Attached please find the East Bay Municipal Utility District's comments on the Draft BDCP and BDCP Draft EIR/EIS.

SUBJECT: Comments on the Bay Delta Conservation Plan and Environmental Impact Report/Environmental Impact Statement

Draft EIR/EIS is Incomplete and Inadequate

Figure 23. South Delta Diversion at Banks

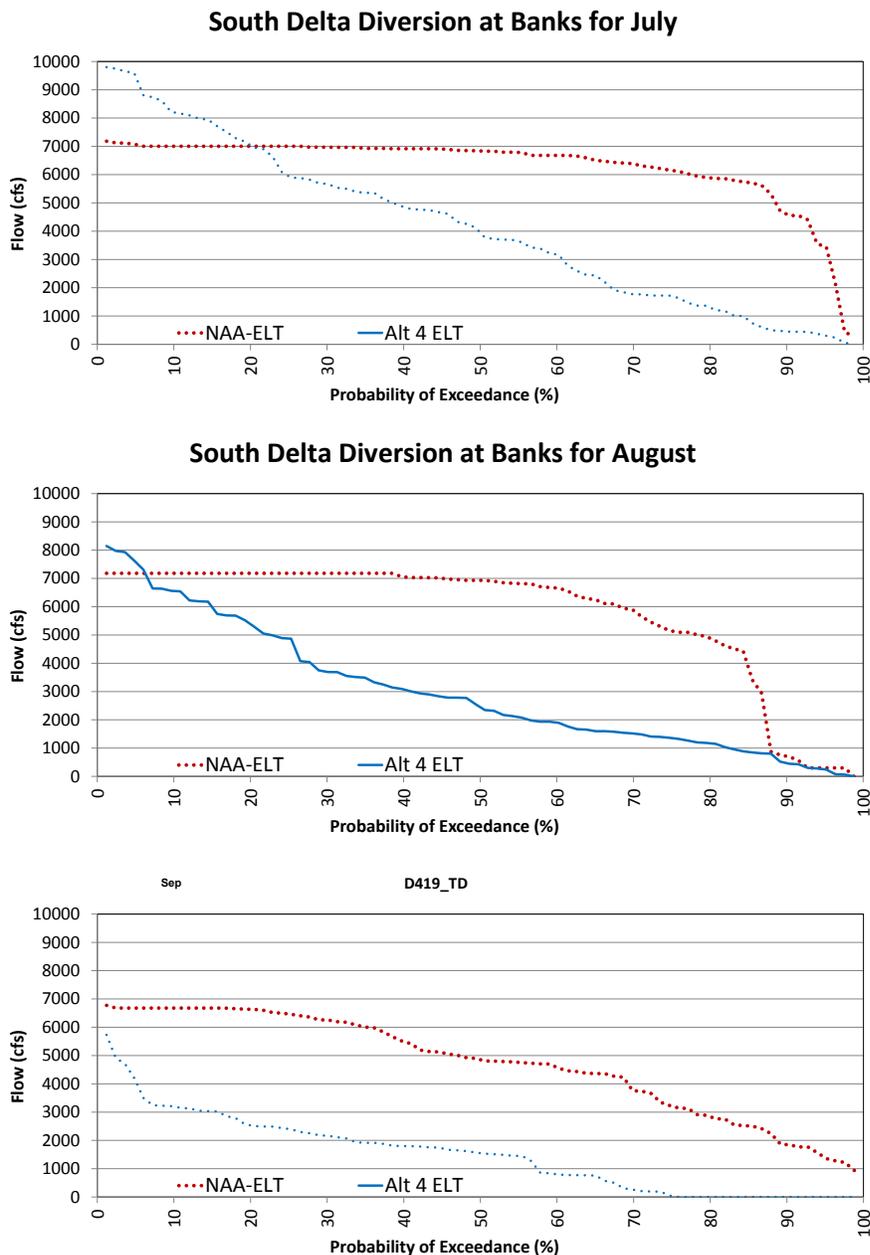
South Delta Diversion at Banks is not limited to existing permit capacity of 6,680 cfs and pumping may reach full capacity of 10,300 cfs in July, August, and September. Figure 23 contains exceedance probability charts of South Delta Diversion at Banks for July, August, and September. The chart for July shows SDD at Banks exceeding existing permit capacity 20% of years, in August this occurs in about 7% of years. There are South Delta diversions at Banks 25% of the time in September while diversions from the Sacramento River may range from 2,500 cfs to 7,500 cfs.

Figure 33. Freemont Weir vs. Sacramento River NAA-ELT

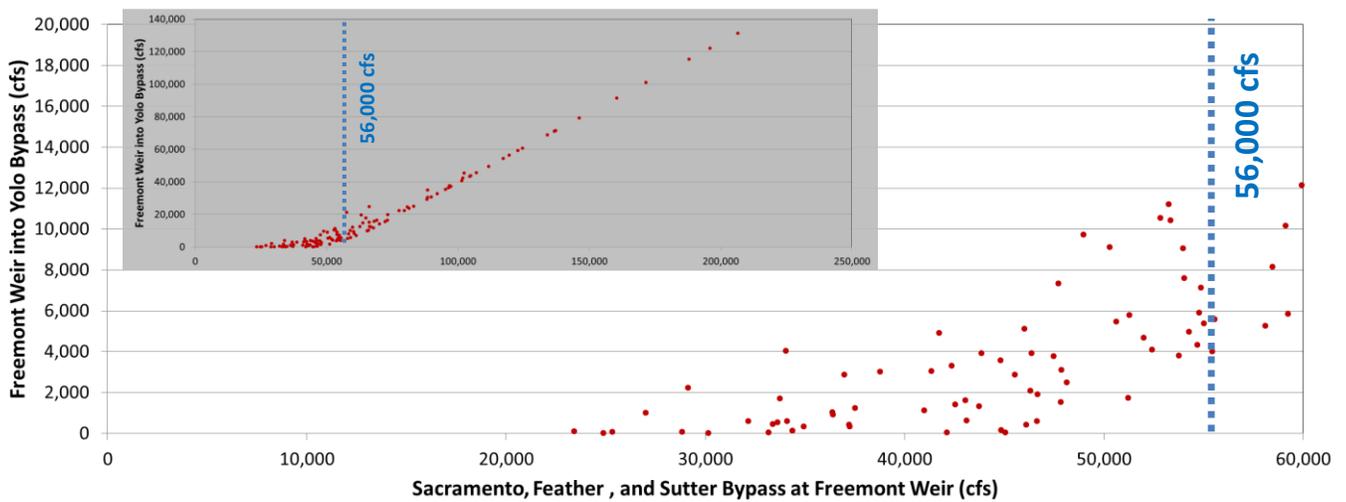
A component of the BDCP Alternative 4 is a modification to the Freemont Weir to allow water to flow into the Yolo Bypass when the Sacramento River is at lower flow than is currently needed. Currently, the Sacramento River does not flow over the Freemont Weir until flow reaches about 56,000 cfs. With the proposed modification Sacramento River flow may enter the Yolo Bypass at much lower flow levels. Figure 33 and Figure 34 contains charts that compare Freemont Weir flow into the Yolo Bypass to Sacramento River flow at the weir, Figure 33 show this relationship for the NAA-ELT and Figure 34 shows this same relationship for Alt 4-ELT.

Although CalSim II is a monthly time-step model, it contains an algorithm that estimates daily flow. Therefore, average monthly flows displayed in Figure 33 shows Sacramento River entering the Yolo Bypass at flow levels less than 56,000 cfs, when this occurs water is flowing over the Freemont Weir for a portion of the month. There is a 100 cfs minimum flow diversion from the Sacramento River diversion to the Yolo Bypass from September through June in Alt 4-ELT.

Figure 44. Alt 4 North Delta Diversion Versus South Delta Diversion for July, August, and September

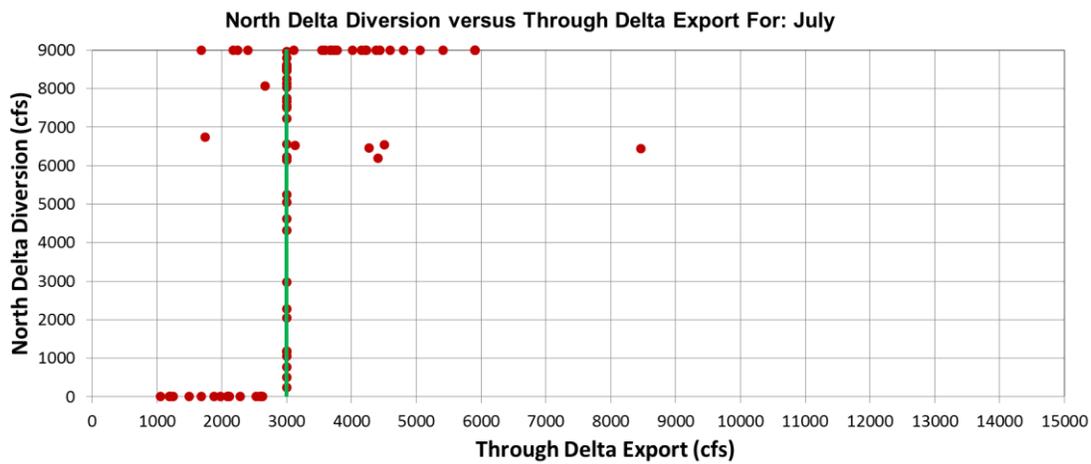
Figure 44 contains modeling results from Alt 4 for July, August, and September that plot NDD against SDD (Through Delta Export). There are many occasions when SDD are 3,000 cfs, which is due to criteria specifying that SDD during this time period need to be at least 3,000 cfs prior to diverting at the NDD facility. Although there are about six occurrences in July and three in August where the model did not satisfy this criterion, this issue has not yet been addressed for this modeling effort.

Figure 60. NDD, and Sacramento River Flow

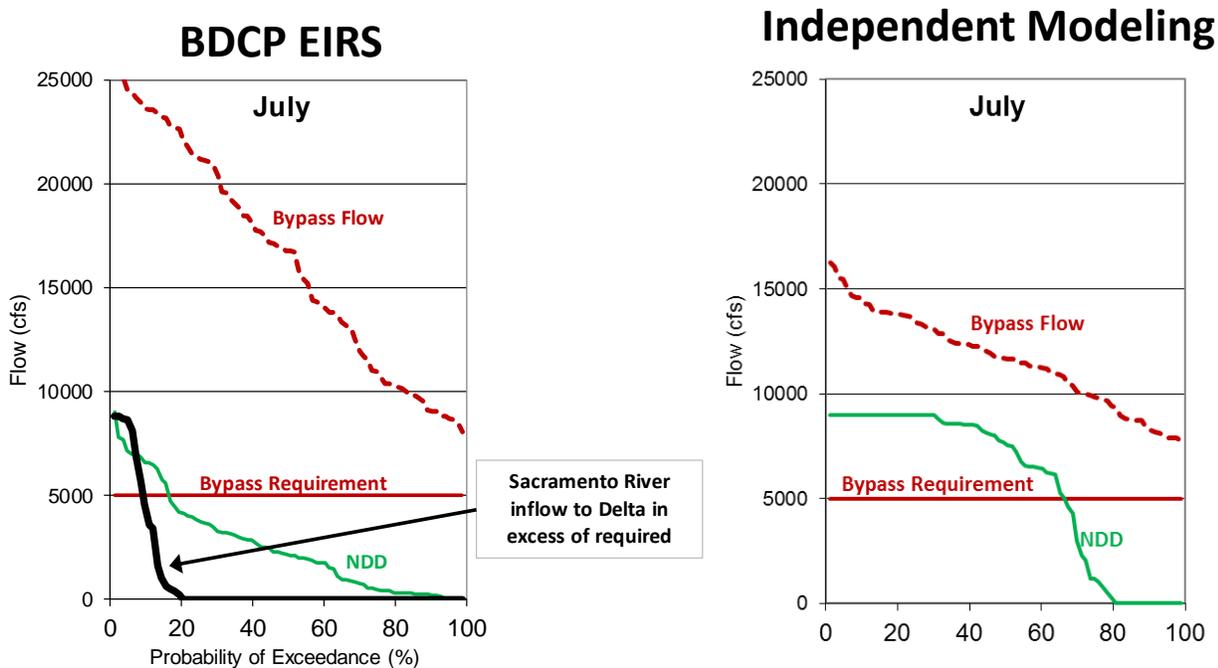
Independent modeling shows greater NDD during July and other months because the BDCP EIRS modeling includes artificially high Sacramento River bypass flow requirements. Figure 60 contains exceedance probability plots of Sacramento River required bypass, Sacramento River bypass flow, NDD, and excess Sacramento River flow to the Delta. As can be seen in Figure 60, bypass flow is always above the bypass requirement. The BDCP version of CalSim sets a requirement for Sacramento River inflow to the Delta that the independent modeling does not need in order to satisfy Delta requirements, therefore the NDD is higher in the independent modeling.

Figure 61. Sacramento River below Hood

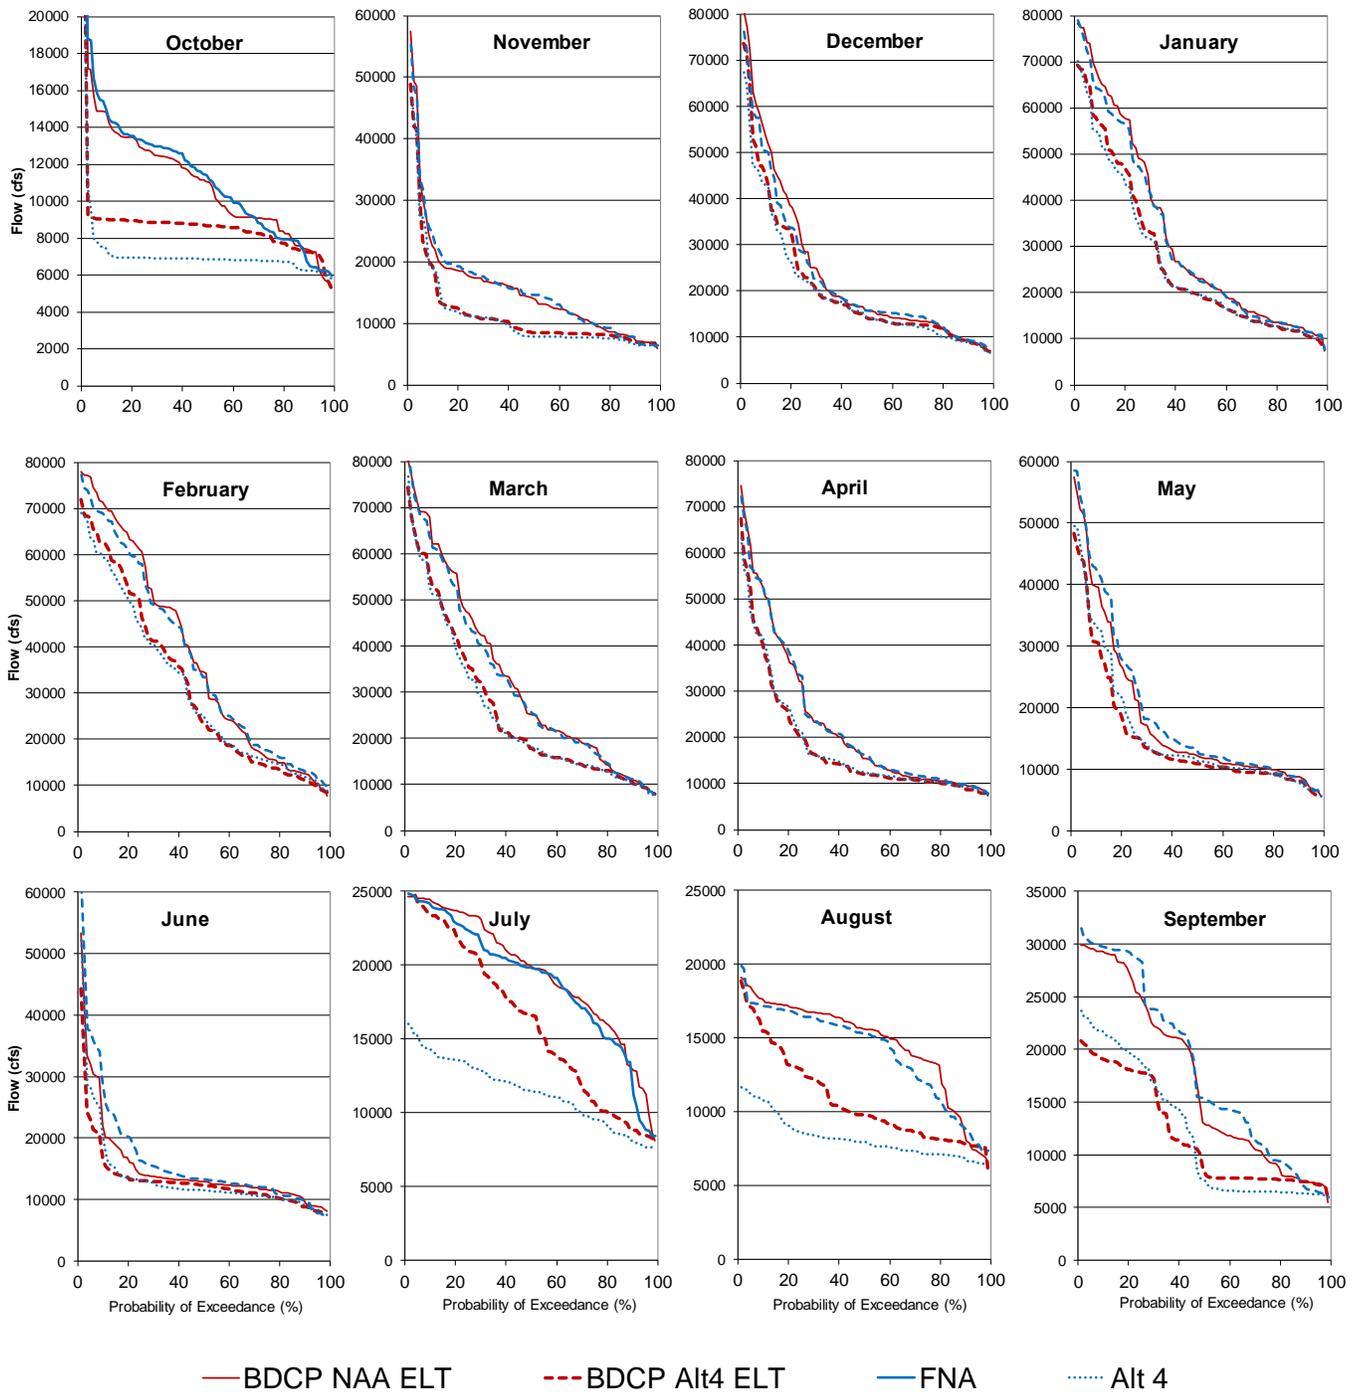
Figure 61 contains monthly exceedance probability plots for Sacramento River below the NDD for the following scenarios: 1) BDCP NAA-ELT, 2) BDCP Alt 4-ELT, 3) independent modeling FNA, and 4) independent modeling Alt 4. The most significant differences in flow changes occur in October, July, August, and September. Changes in Sacramento River flow entering the Delta are a key indicator of changes in interior Delta flows, water levels, and water quality.

In the independent modeling September flows are reduced by about 6,100 cfs while BDCP modeling shows a reduction of about 5,300 cfs. The independent modeling shows Sacramento River flow entering the Delta to be about 7,000 cfs 50% of the time, BDCP modeling show Sacramento River flow is about 8,000 cfs 50% of the time.

TITLE: Mokelumne Aqueducts and Delta Tunnel Plan	
PROJECT: Mokelumne Aqueducts Delta Tunnel Study	
<small>DATA REFERENCES: Coordinate System: NAD 1983 StatePlane California II FIPS 4023 Feet Projection: Lambert Conformal Conic Datum: North American 1983 Units: Foot US</small>	
FIGURE 1

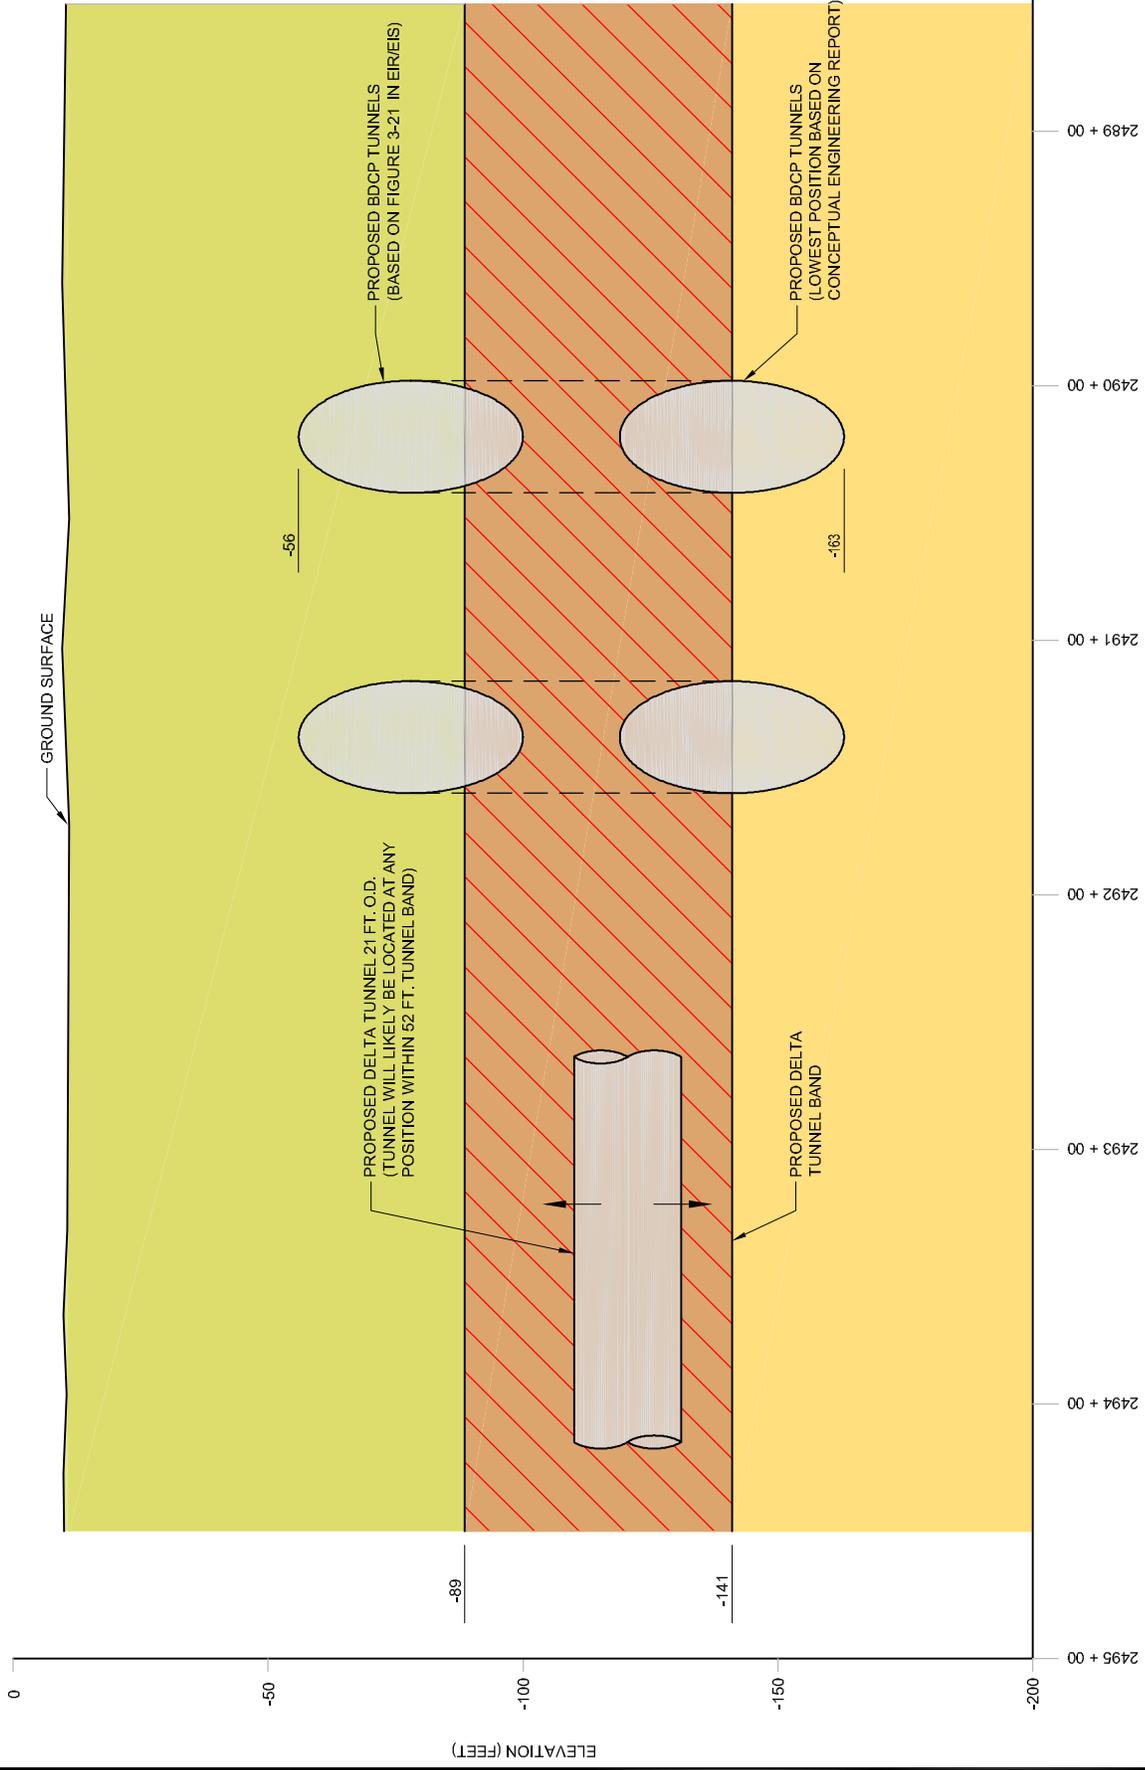
The BDCP Conveyance Tunnels are shown in the DEIR/EIS to cross the EBMUD Aqueducts in the middle of Woodward Island, which is within the Delta area, and is shown on **Figure 1 - Mokelumne Aqueducts and Proposed Delta Tunnel Plan**. Within the crossing location, all three Aqueducts are elevated and on piles, with pile tips ranging from approximately 30 to 50 feet deep, corresponding to elevations of -40 to -60 feet msl.

Figure 2: Reverse Flow Incidents per Year with Advective Transport Exceeding 0.9 Miles for MBK Modeling Studies, 1921-2003 Hydrology.

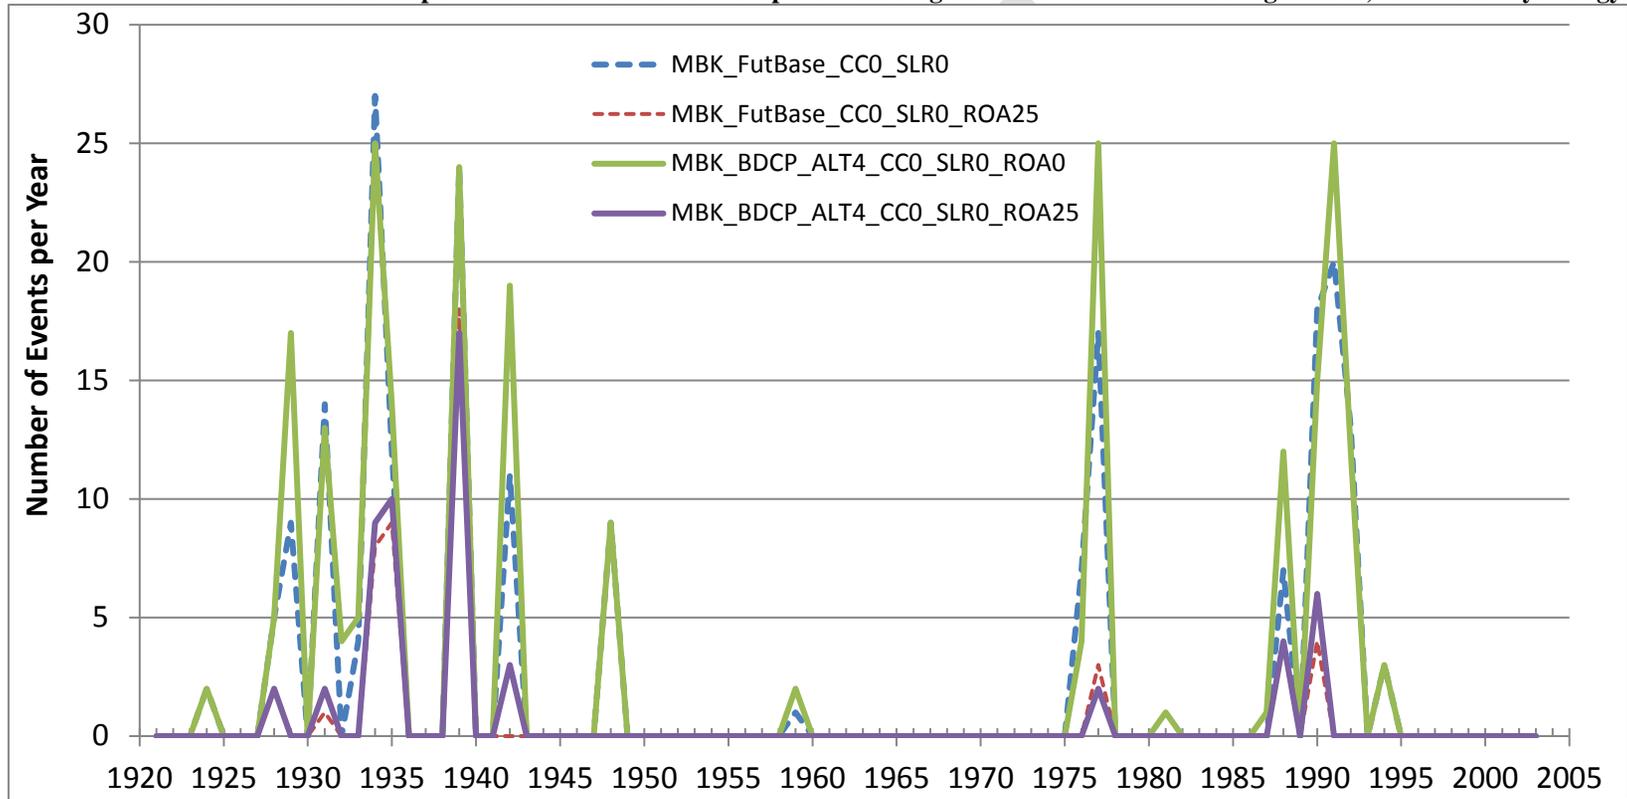
- Additional modeling performed by CCWD simulated the full hydrologic period that was simulated with Calsim2²⁵. This modeling provided additional clarifying information regarding the effect of the two components of the project isolating the effect of restoration. Four DSM2 model simulations were analyzed as described in Table 1. The number of reverse flow events for the full 83-year period of record and shorter 19-year period that would result in a shutdown of FRWA are presented in Table 4. The distribution of the number of reverse flow events per year is plotted in Figure 2.

Figure 3: Sacramento Valley Water Year Hydrologic Classification Frequency for Calsim2 Hydrologic Period (1921-2003, 83 years) with DSM2 Hydrologic Period (1976-1991, 16 years).

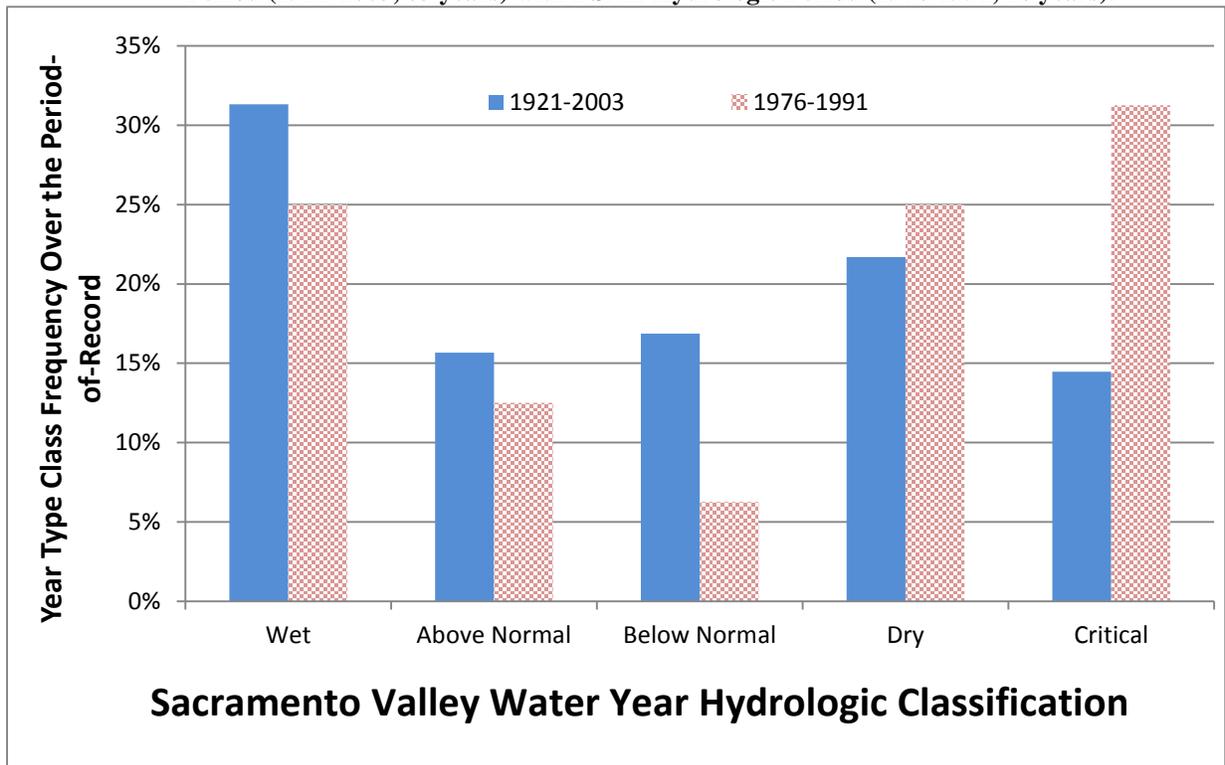
- Table B-9 DSM2 Inputs page 5A-B73 reports that the period simulated is a 16-year period 1976 through 1991. This represents a shortened hydrologic period simulated relative to the Calsim2 model that simulates an 83-year period from 1921 through 2003. The shortened 16-year period covers the two main drought periods²⁷; however, this shorter 16-year period is skewed towards drier year types (see Figure 3). On the basis of the Sacramento Valley Water Year Hydrologic Classification, the Dry and Critical year types are the most frequent (at 56%) relative to Wet, Above Normal, and Below Normal year types (44%) in the 1976 through 1992 period. For the longer period of hydrology simulated with Calsim2, the wetter year types (*i.e.* Wet, Above Normal, and Below Normal) account for 66% of the 83-year period whereas the Dry and Critical year types account for 37%. While reverse flow events are expected to occur in the drier year types which are over-represented in the shorter 16-year period, the purpose of the impacts analysis is to discern the impact of the proposed project as compared to the no project or no action. Considering that the project effects are greatest in the wetter year types when regulatory constraints on the system are less restrictive to project operations, the approach of simulating a shorter period that is relatively dry means that the impacts analysis is based on a period in which the project operation is more constrained. Furthermore, since DSM2 boundary conditions are available for the full 83-year period of record, the reason to limit the DSM2 model to a shorter and drier hydrologic period seems arbitrary. Simulating a longer hydrologic period with more variation in hydrologic conditions seems more appropriate to base the analysis of potential impacts of the proposed project.
